STATE OF MAINE
DEPARTMENT OF TRANSPORTATION
16 STATE HOUSE STATION
AUGUSTA, MAINE 04333-0016

January 18, 2022
Subject: Penley Avenue Bridge Deck
Replacement
State WIN: 021758.00
Location: **West Paris**
Amendment No. 2

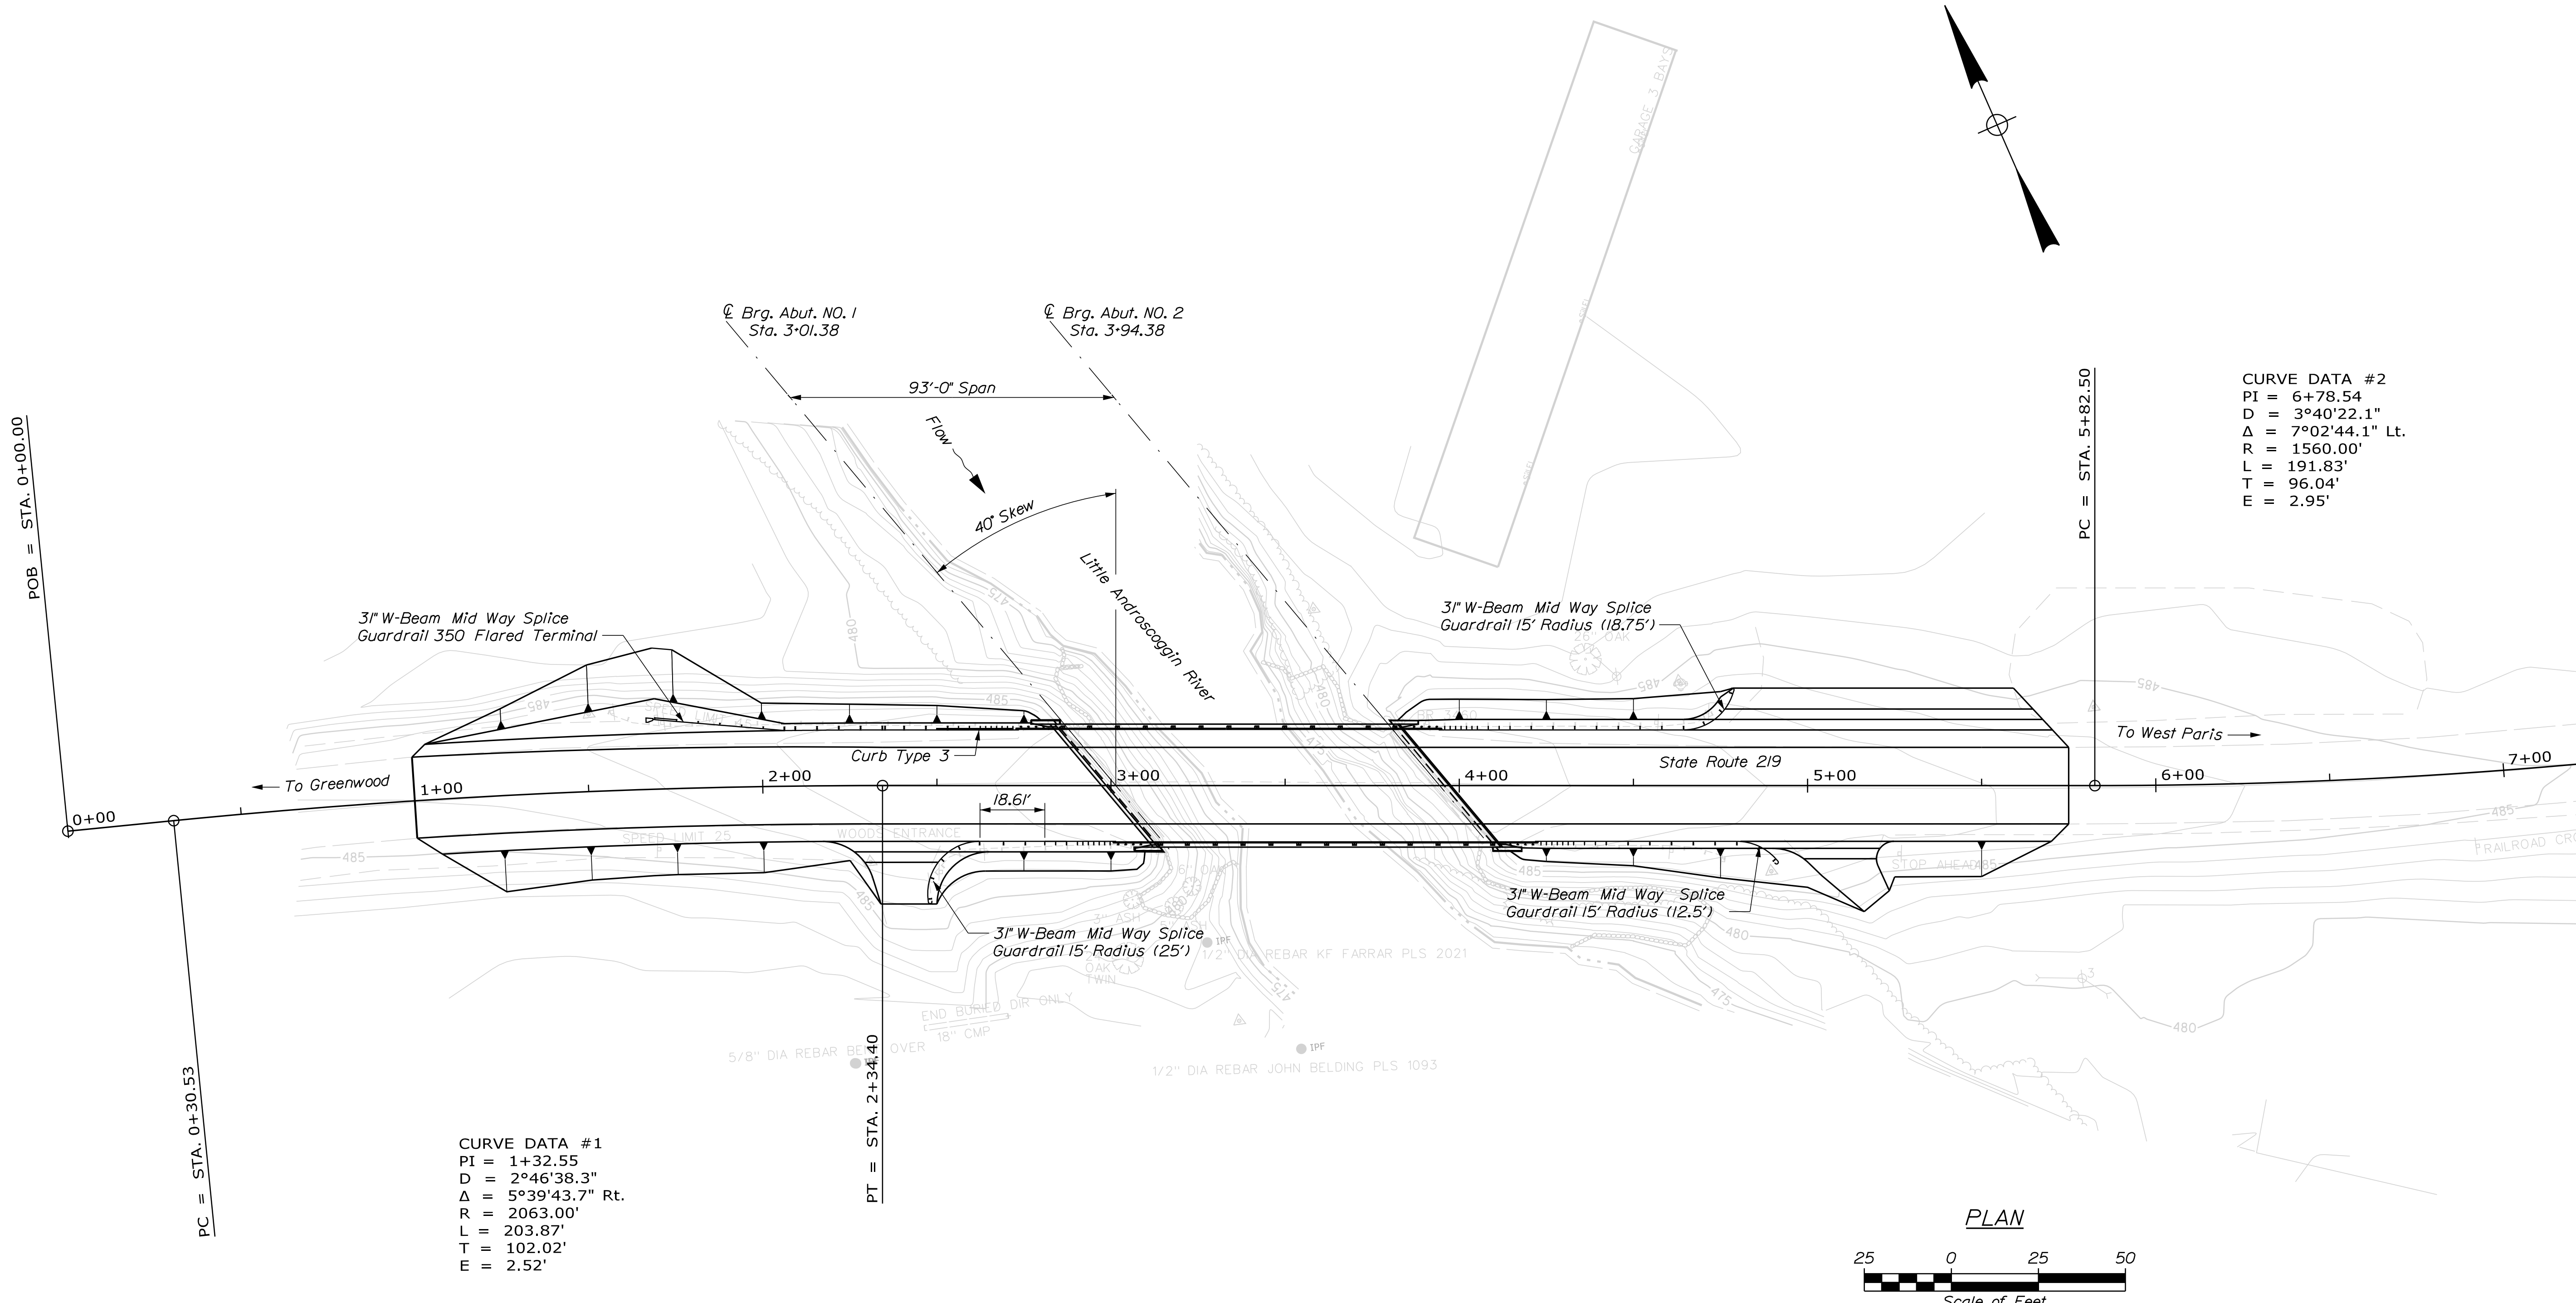
Question: In which Item does the abutment and wing wall concrete pay under?

Response: Please see updated schedule of items and plan sheet 2 for pay items associated with abutment and wingwall work.
